**FAIRCLOTH - GARAGE  
5244 COOL SPRINGS RD  
BROADWAY, NORTH CAROLINA**

**FOUNDATION PLAN**

**ENGINEERED SUBMITTAL**  
 This submittal has been reviewed for specified design criteria & compatibility with building structure. The design of these components is the responsibility of those providing the components.  
 HMHendrick Enterprises, Inc.  
 By: **HMH** Date: **09/30/25**

**Johnny Faircloth**  
**Garage**  
**ROOF PLACEMENT PLAN**

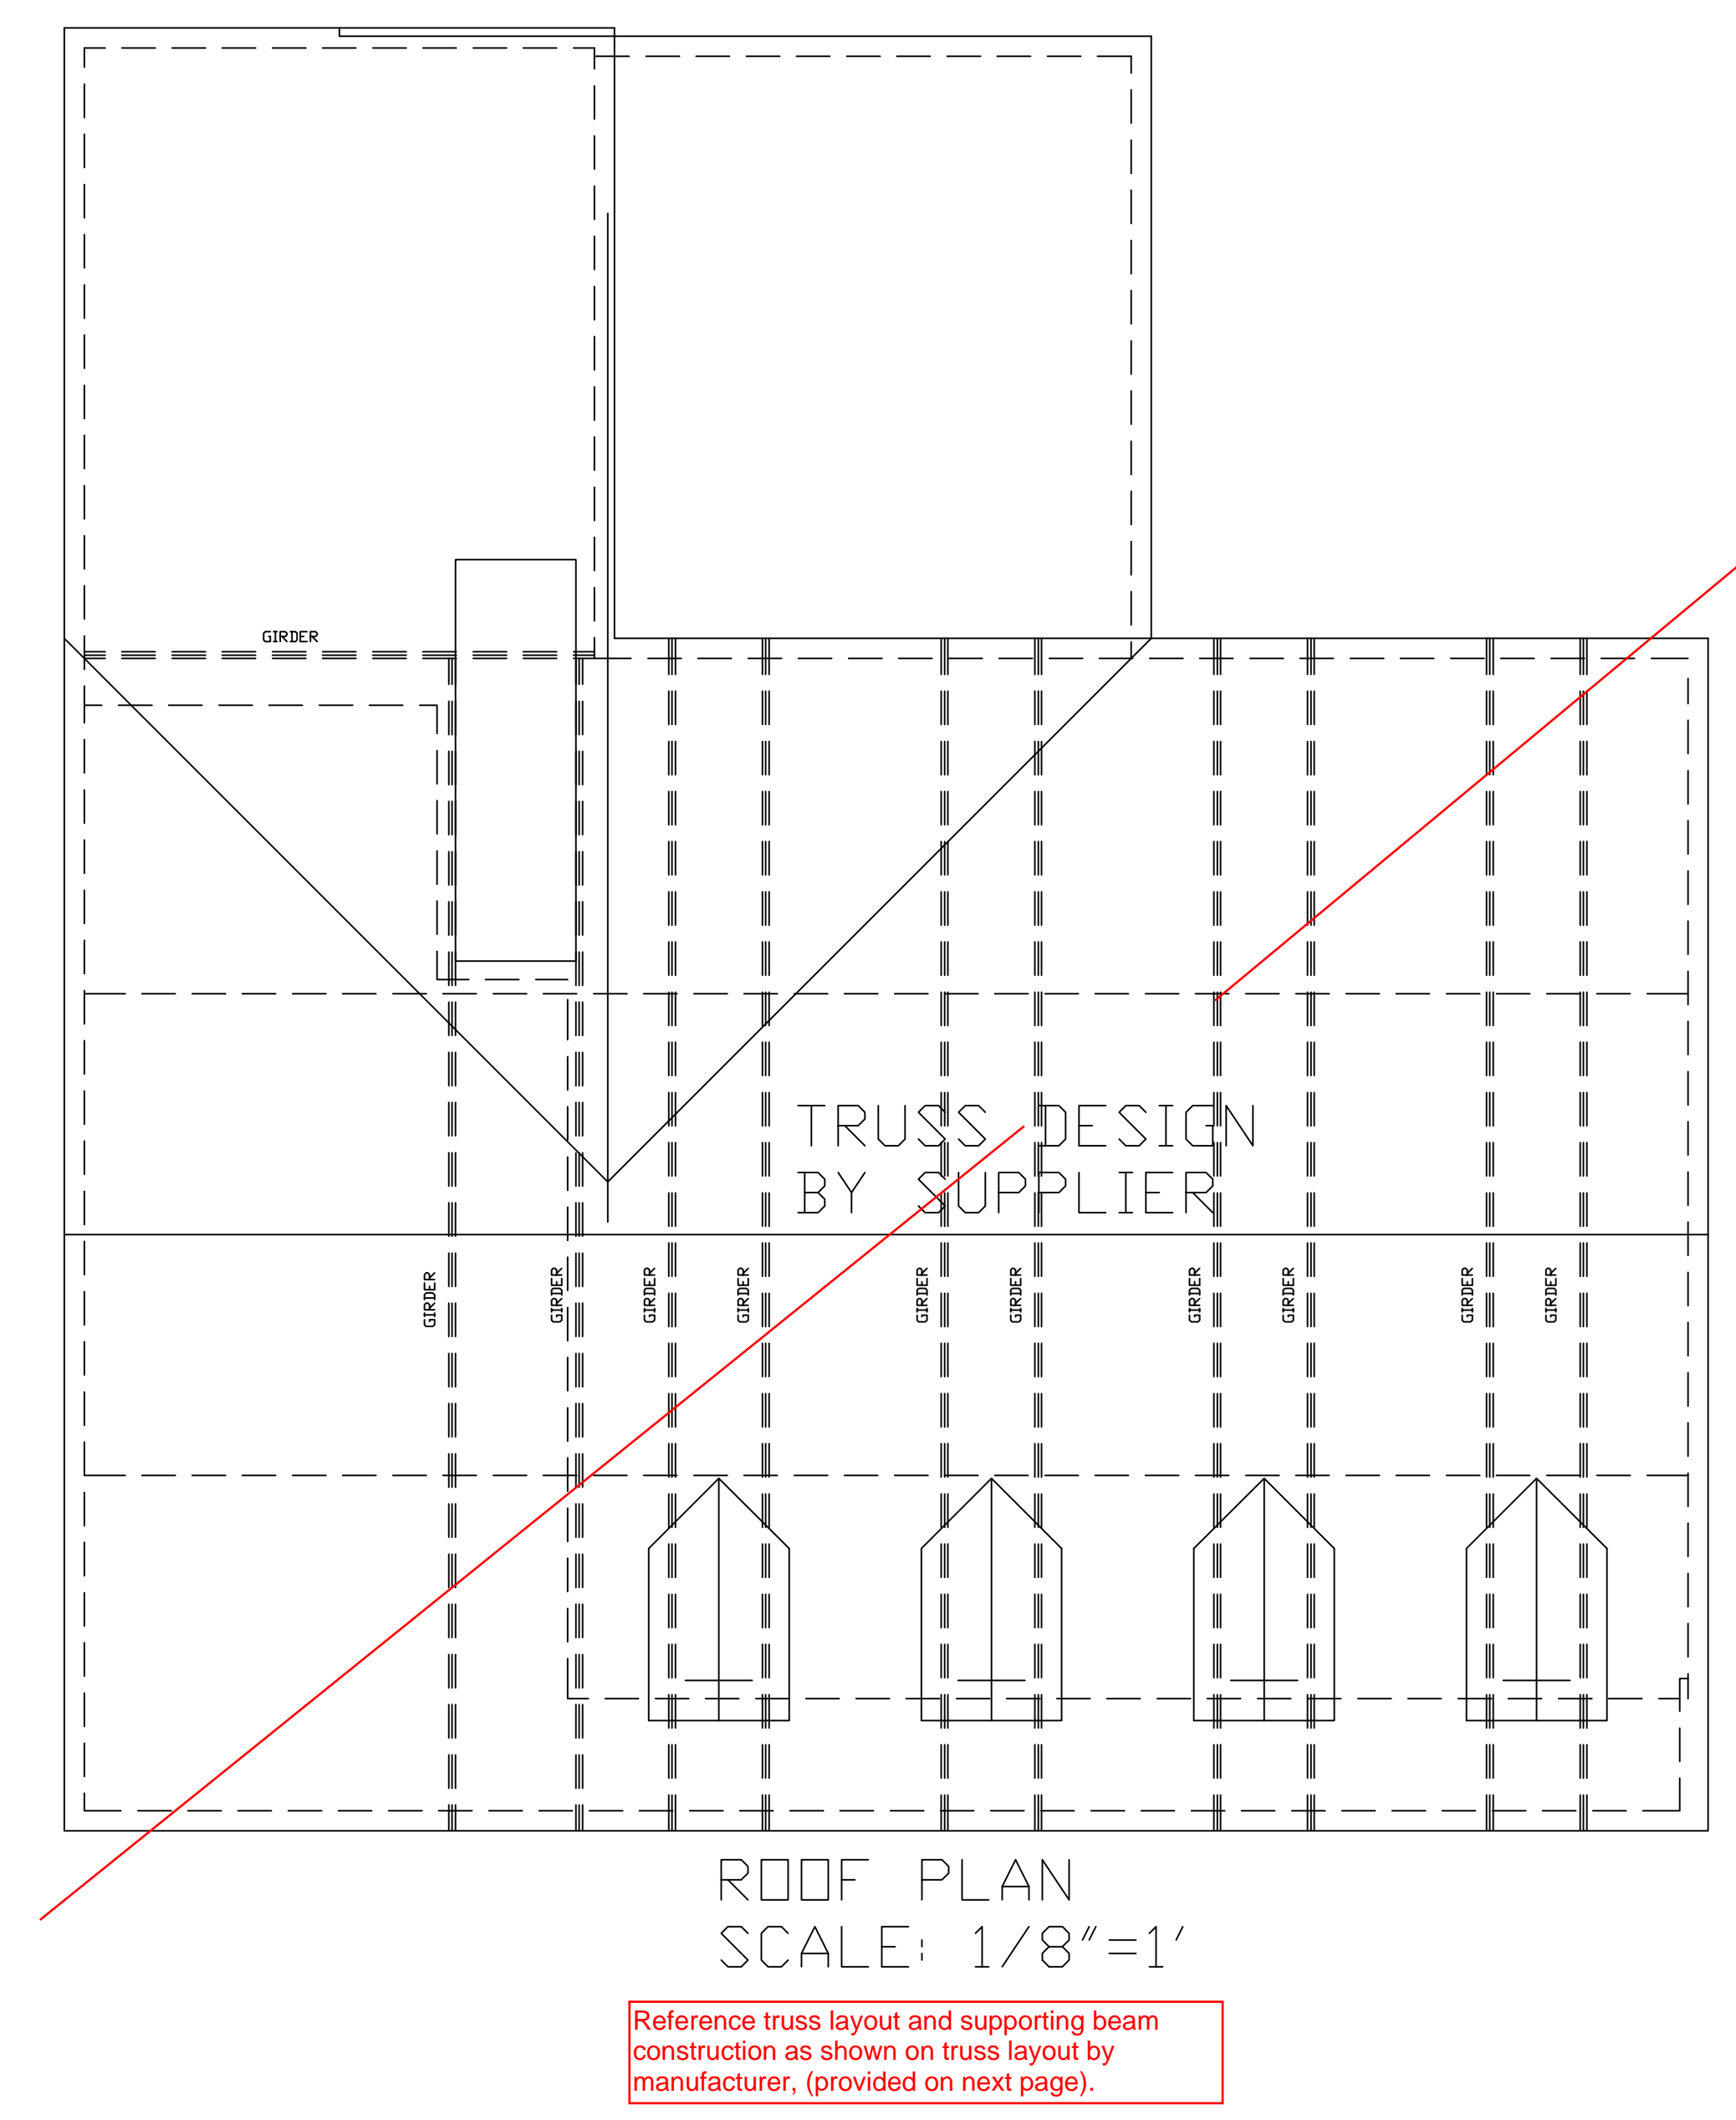
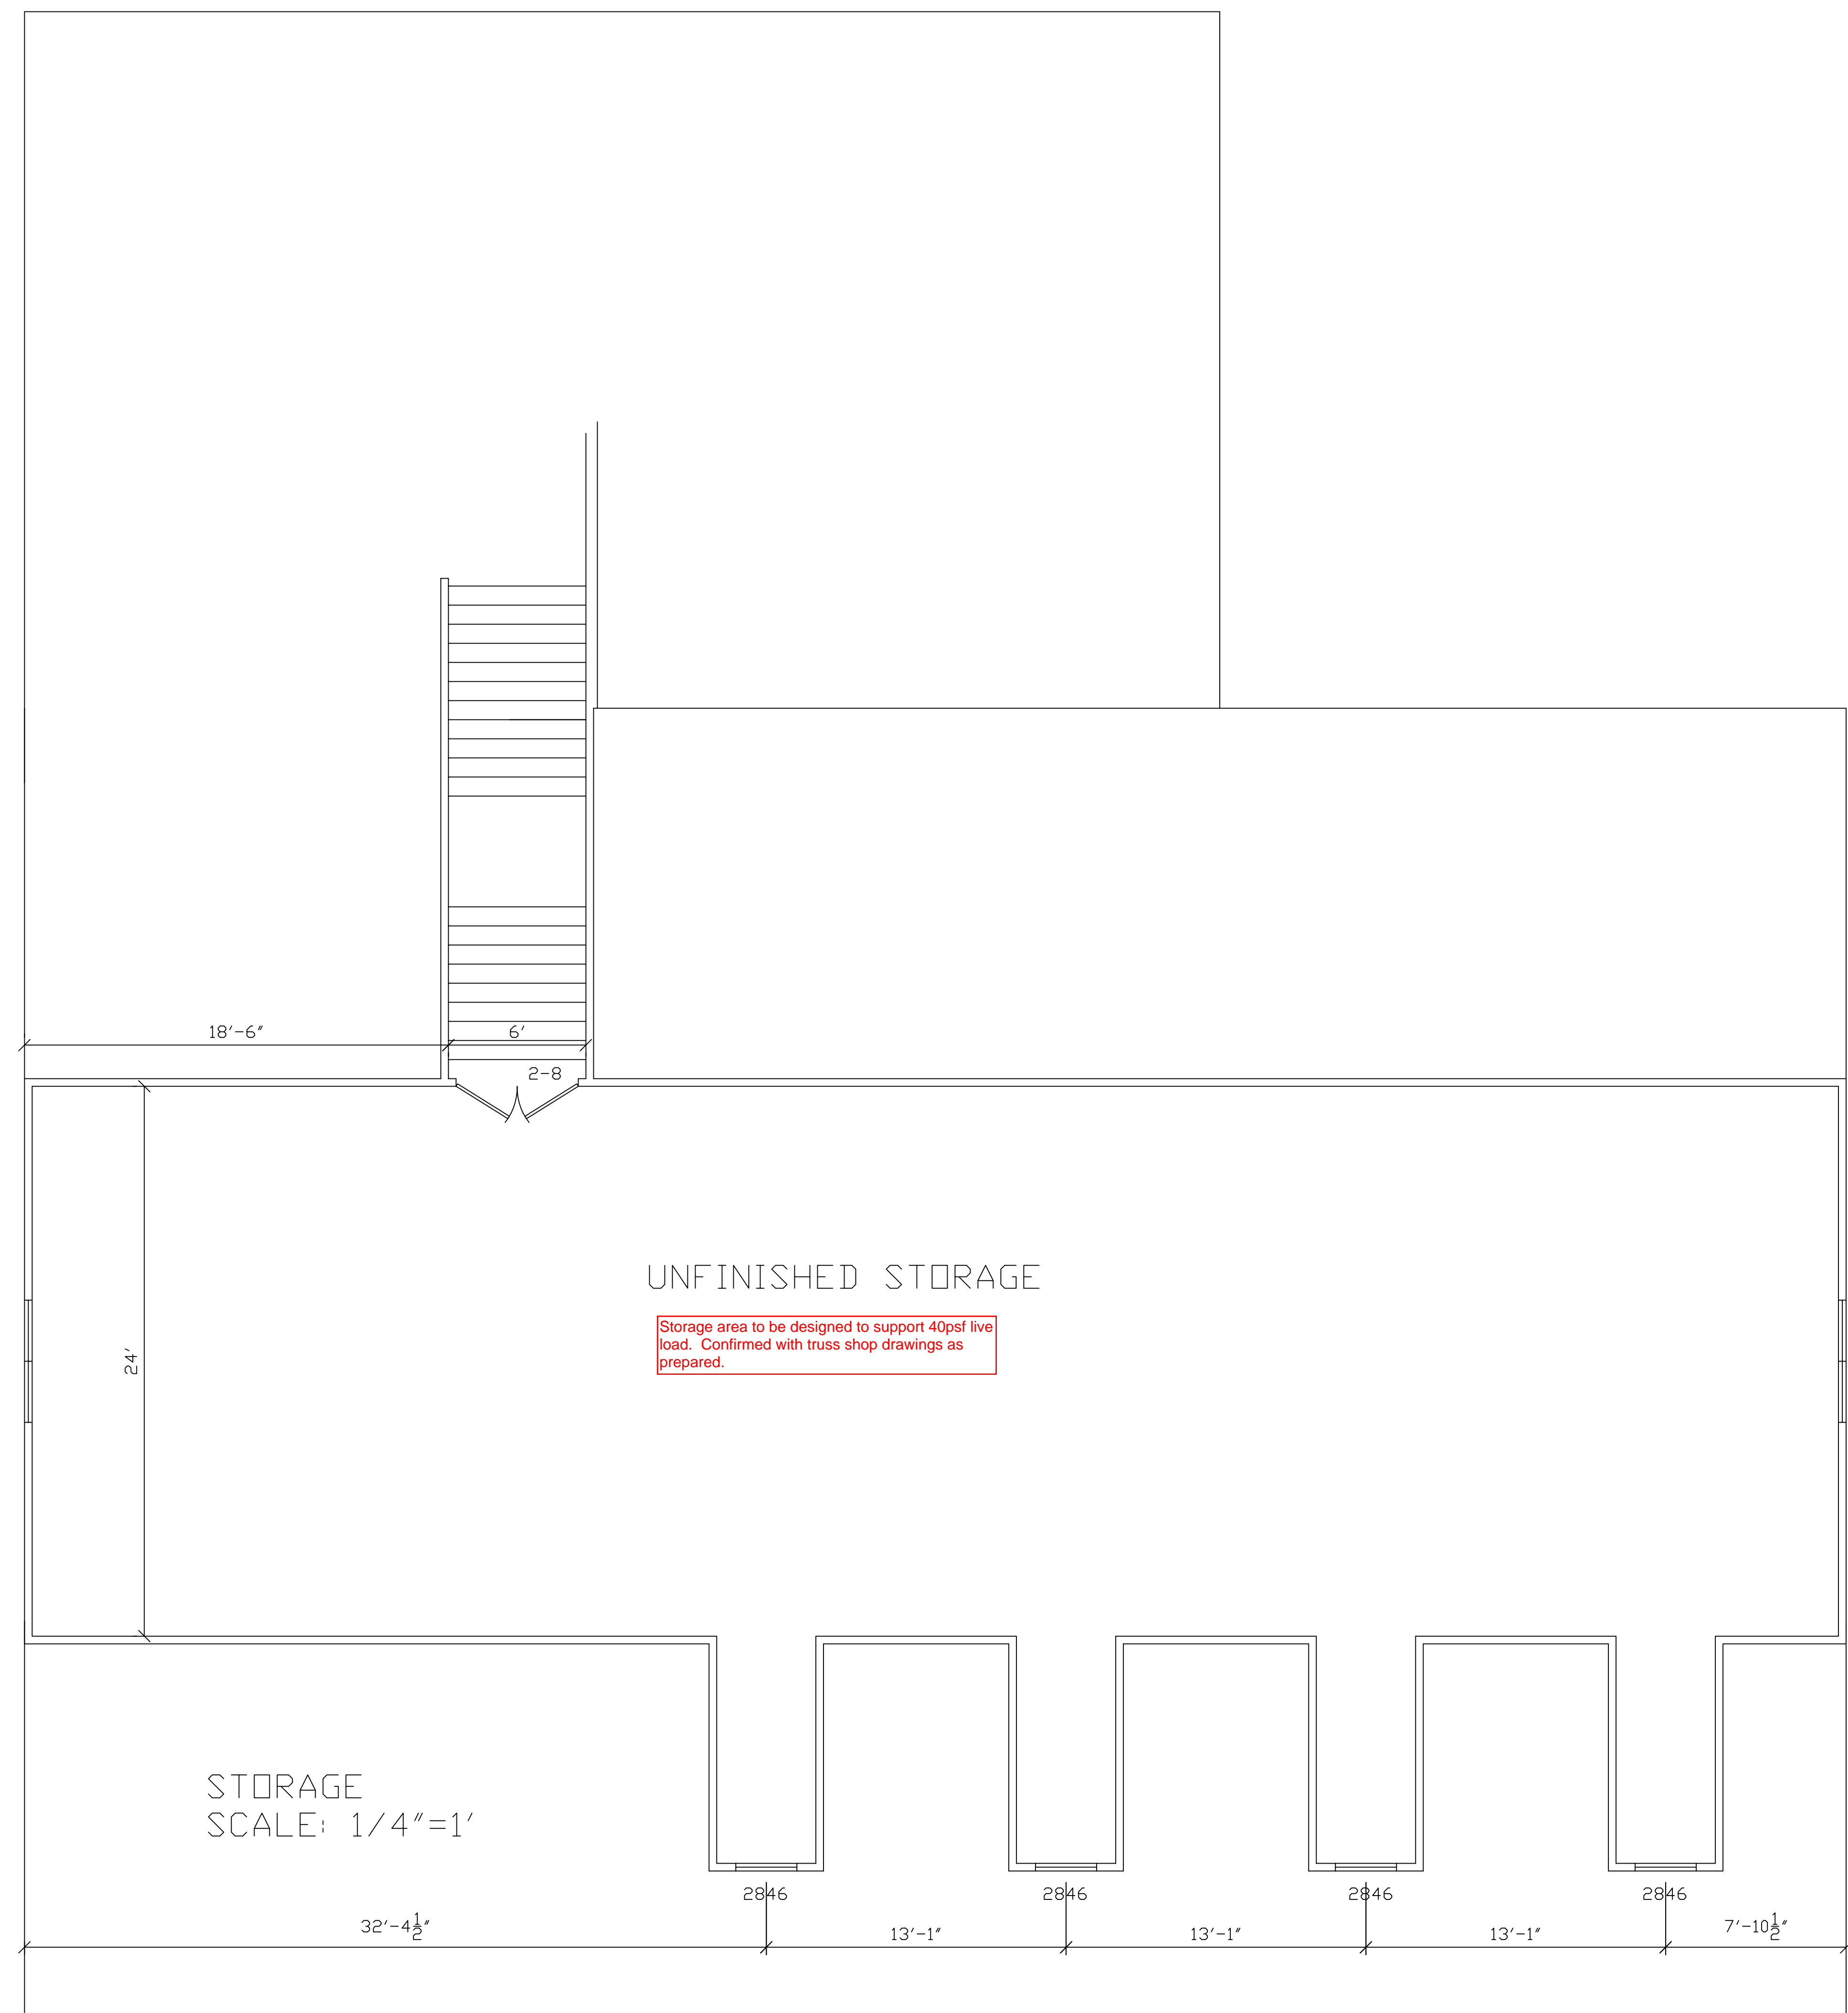
12" turn-down slab w/ (2) #5 cont. at perimeter of carport, (heavy equipment).

Simpson HDU-11-SDS2.5 HOLDOWN ANCHOR AT EA. END OF PORTAL FRAME DOORS ALONG THIS SPAN (4 TOTAL). ATTACH TO FOUNDATION w/ 1" DIA. THREADED ROD SET IN HILTI RE500 EPOXY OR EQUIV. (8" MIN. EMBED).

48" (min.) braced wall panel/ portal frame between adjacent garage doors, and corners, given building height, (typical).

12" turn-down slab w/ (2) #5 cont. at perimeter of apron, (heavy equipment).

36"x36"x12" thick (min) spread footing w/ (3)-#4 ea. way (typical 7x).

60"x60"x12" thick (min) spread footing w/ (5)-#4 ea. way (typ. 2x as shown for uplift).
